Access Compliance Report

Public Rights-of-Way

Intersection ID: 23171	Main Street: CAMILLA_DR	Cross Street: MORROWICK_RD	Location: SE
ADA ID: ADCC68C8DFDC	Ramp Type: PerpDiag	Initial Pass/Fail: Fail	Overall Compliance: No
Severity Score: 12.5			
Codes/Mitigation Info/Possible Solution		Field Measurements/Component Compliance

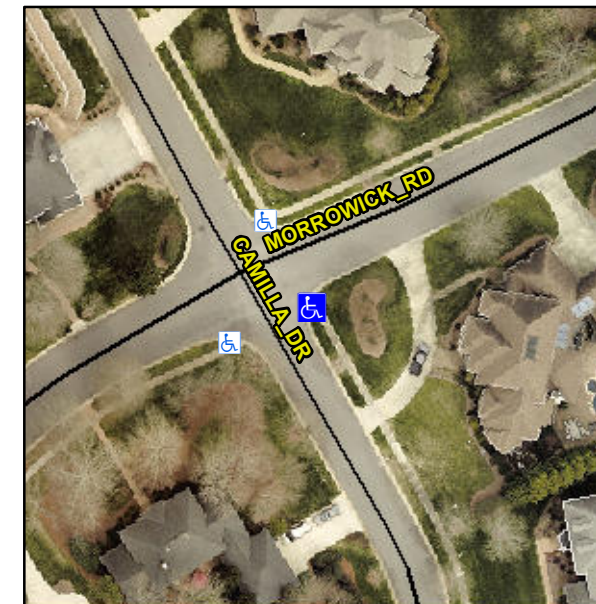
Not Found, R304.5.3

Compliance	Description	Data	Compliance	Description	Data
N/A	Ramp Length (in)	77.0	Yes	Ramp Slope (%)	5.5
Yes	Ramp Width (in)	48.0	No	Ramp XSlope (%)	6.8
N/A	Flare Type LT	N/A	N/A	Flare Type RT	N/A
N/A	Flare Slope LT (%)	N/A	N/A	Flare Slope RT (%)	N/A
N/A	Flare Traversable LT?	N/A	N/A	Flare Traversable RT?	N/A
N/A	Landing Length (in)	N/A	N/A	DWS Provided?	N/A
N/A	Landing Width (in)	N/A	N/A	DWS Contrast?	N/A
N/A	Landing Slope (%)	N/A	N/A	DWS Length (in)	N/A
N/A	Landing X Slope (%)	N/A	N/A	DWS Full Width?	N/A
N/A	Landing Curb? (Y/N)	N/A	N/A	DWS Offset (in)	N/A
N/A	Shared Landing?	N/A			
N/A	Gutter Ponding?	N/A	N/A	Gutter Slope (%)	N/A
N/A	Gutter Lip Ht (in)	N/A	N/A	Gutter X Slope (%)	N/A
N/A	Painted X Walk1?	No	N/A	Painted X Walk2?	No
	X Walk 1 Direction	To N		X Walk 2 Direction	To W
N/A	X Walk 1 Width (in)	N/A	N/A	X Walk 2 Width (in)	N/A
	X Walk 1 Slope (%)	2.1		X Walk 2 Slope (%)	4.8
	X Walk 1 X Slope (%)	0.5		X Walk 2 X Slope (%)	2.3

Remove & Replace Curb Ramp With Two New Directional Ramps or Equivalent.
